Oakdale West Industrial Estate – SSD7348 MOD 6

Response to Submissions

1 February 2021

Annexure	Document
A	MOD 6 Update Architecture Plans

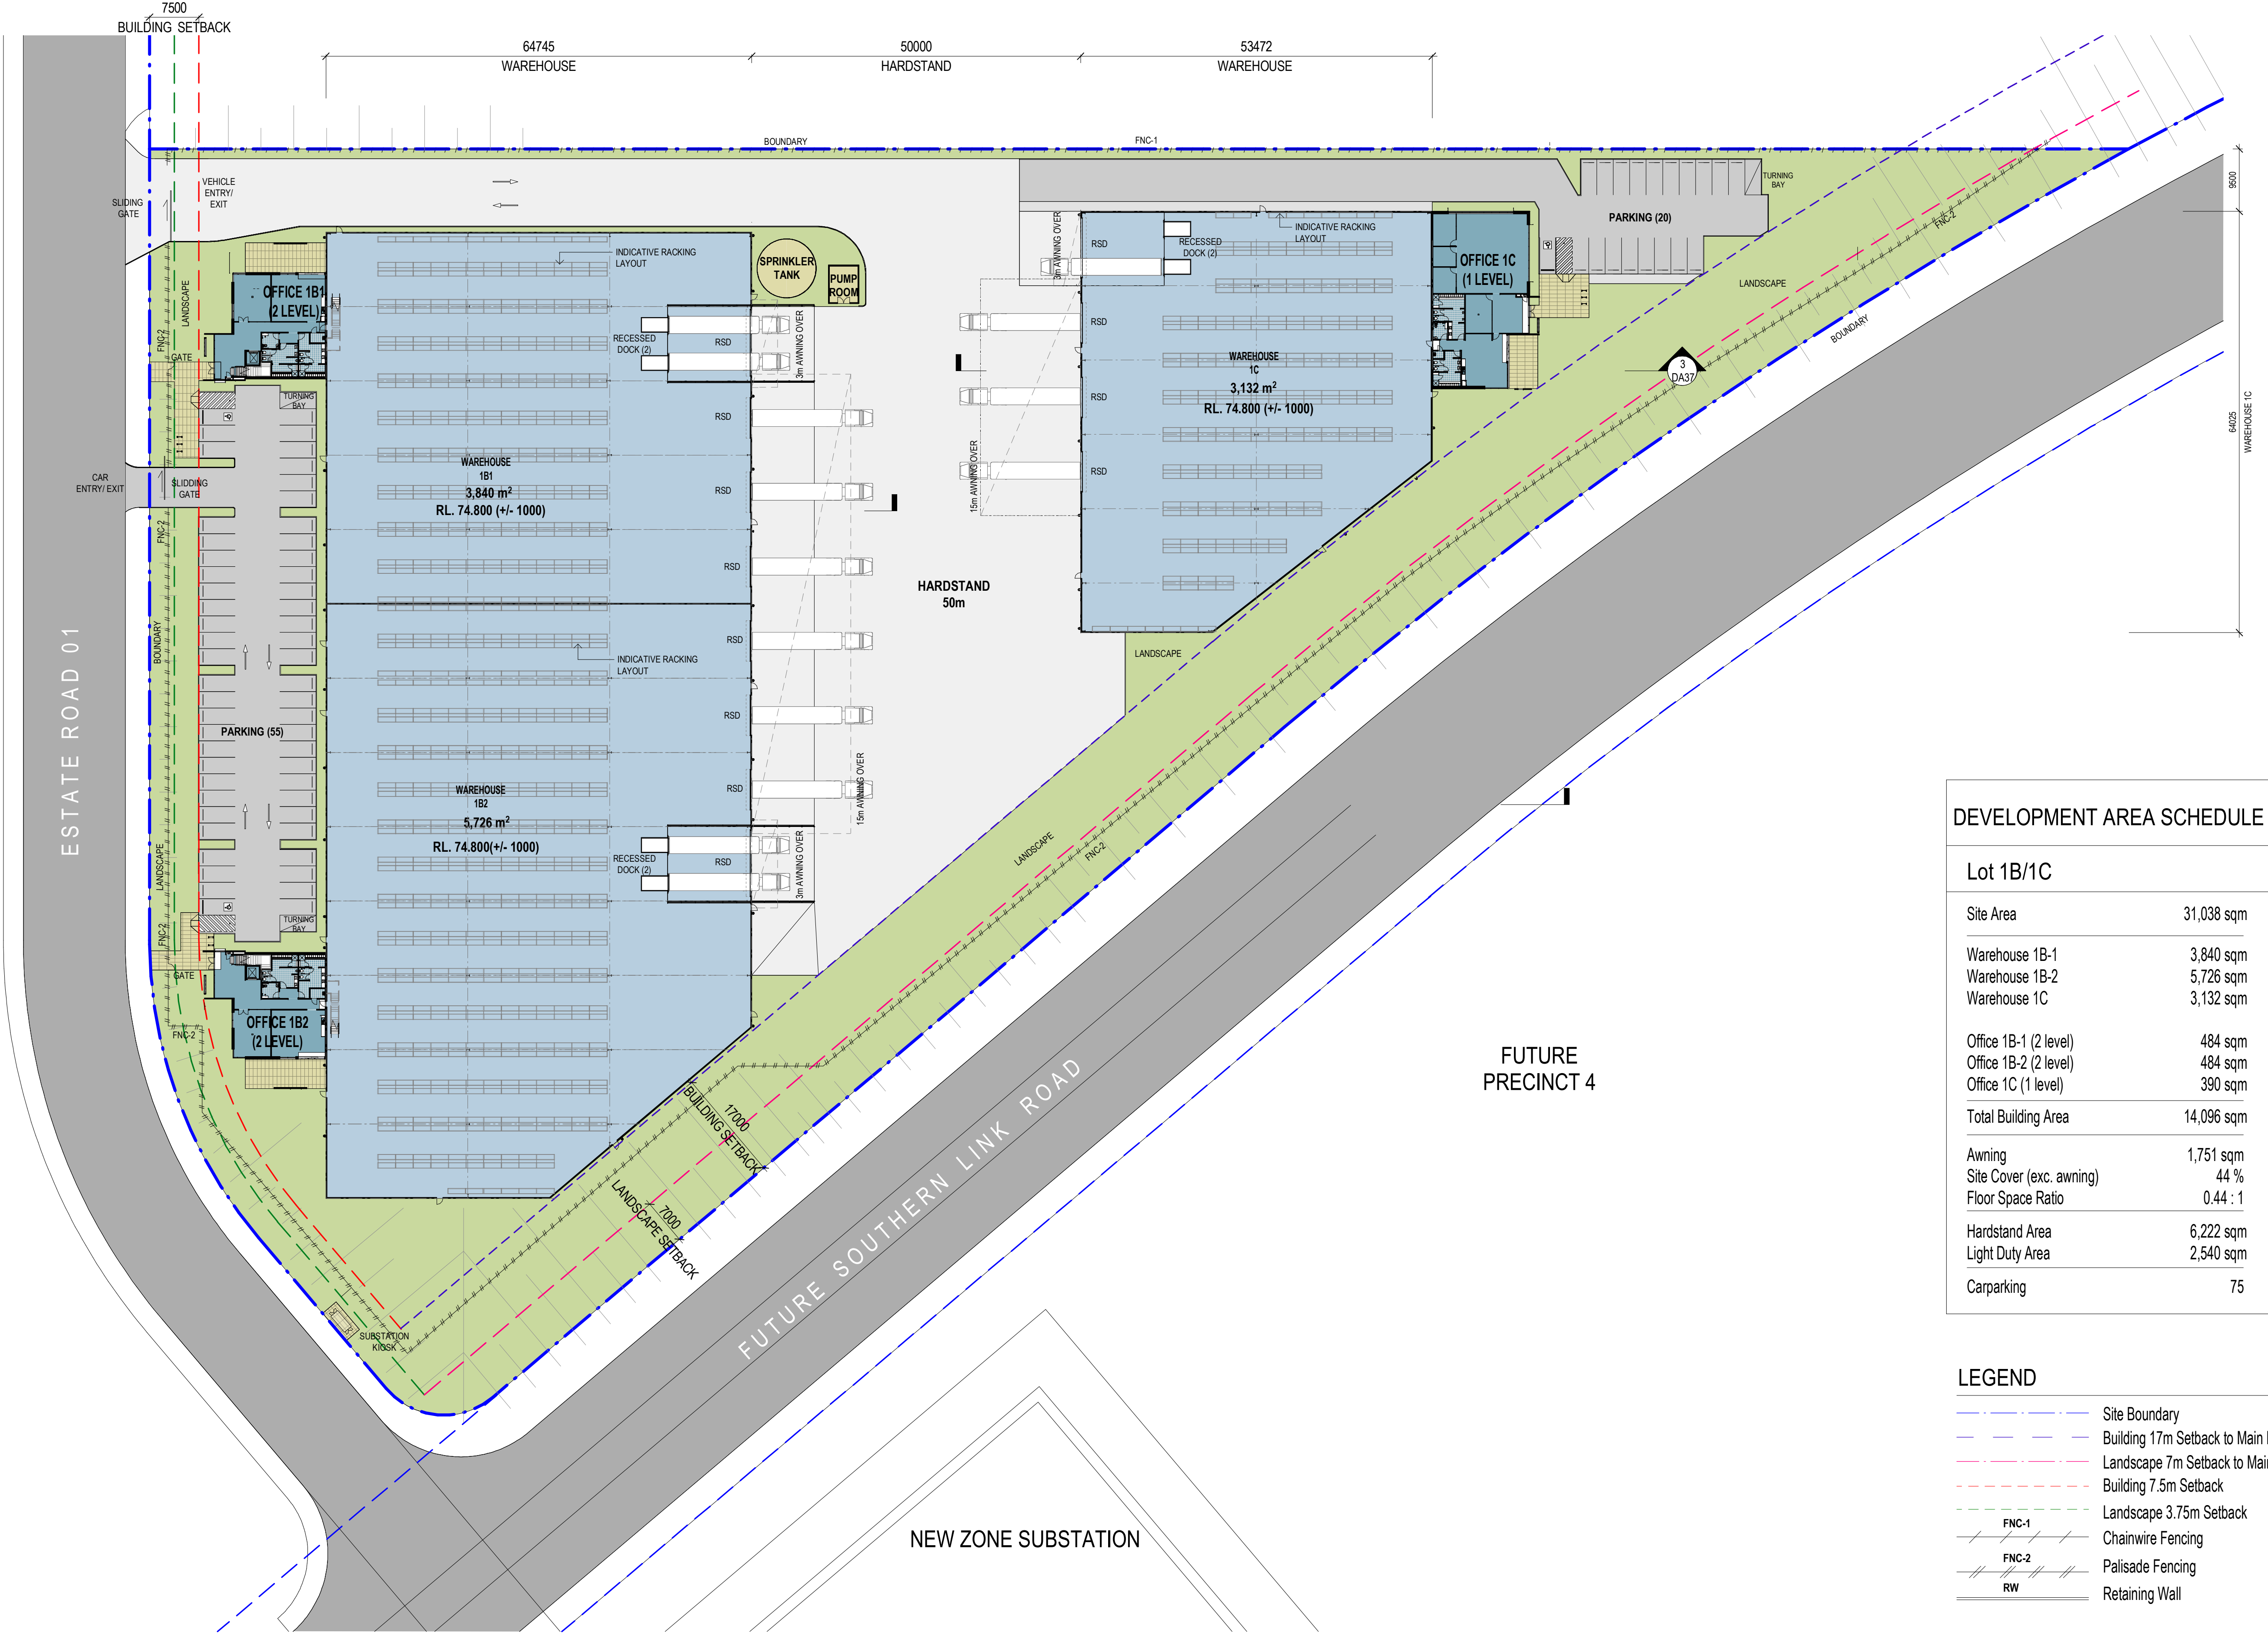
Matters Raised	Applicant Response
<ul style="list-style-type: none"> - Warehouse 1B1 – The indication of bike parking on the above paved area is also unsupportable and should be removed and relocated within the site and not in a location that erodes necessary setback planting between the car park and property boundary. 	<ul style="list-style-type: none"> - The bike parking is not located within landscape setback.
<ul style="list-style-type: none"> - Warehouse 1B2: Same issues as above with Warehouse 1B1 with respect to paving in required landscape setback zone and relocation of indicated bike parking 	<ul style="list-style-type: none"> - Setback response as above. - The bicycle parking has been relocated from the pedestrian path to be located outside of the <i>landscape setback</i> (see Attachment A). - The width of the pedestrian path connecting the 1B2 office to the road has been reduced to limit impact on landscaping, but still comply with BCA access requirements.

<ul style="list-style-type: none"> - The architectural drawing package makes reference to Stage / Building 1A in the precinct on the Major Projects website however the architectural plans only seem to relate to 1B and 1C. It is requested that it be confirmed no changes are proposed to Building / Stage 1A and its surrounding parking and landscaping design (which is believed to have been approved under Mod 5) and that the Precis for these documents be revised to avoid confusion. 	<ul style="list-style-type: none"> - No changes proposed to the Warehouse 1A in MOD6.
<ul style="list-style-type: none"> - The amended master plan provides a diminished landscape setback for Precinct /Stage 3 when compared to what has been required in Stages 1 and 2. As evident within the approved developments within Stage 1A, B & C, as well as Stage 2B, a 7.5m landscaped setback zone has been insisted upon between the property boundary of the public road network and car parking that is situated forward of the building line. To continue this established character as approved, the spatial arrangement of Warehouse Building 3B and 3C should be amended so that a 7.5m landscape setback is maintained to the western side of the eastern road, to reflect the same landscape character as set up via Stage 2B as approved, and what is proposed for 2A, 2C1 and 2C2 via this amendment. Alternatively, car parking 	<ul style="list-style-type: none"> - As discussed, Council have again misinterpreted the approved DCP setback controls. - The <i>building setback</i> for all internal estate roads are 7.5m, and associated landscape setbacks at 50% of this width, or 3.75m. - The proposed setbacks for Stage 1A, B, C; Stage 2B; and Stage 3B all remain consistent with the approved DCP building and landscape setback controls. - To ensure consistency throughout the precinct, uniform setbacks are included in the architecture plans.
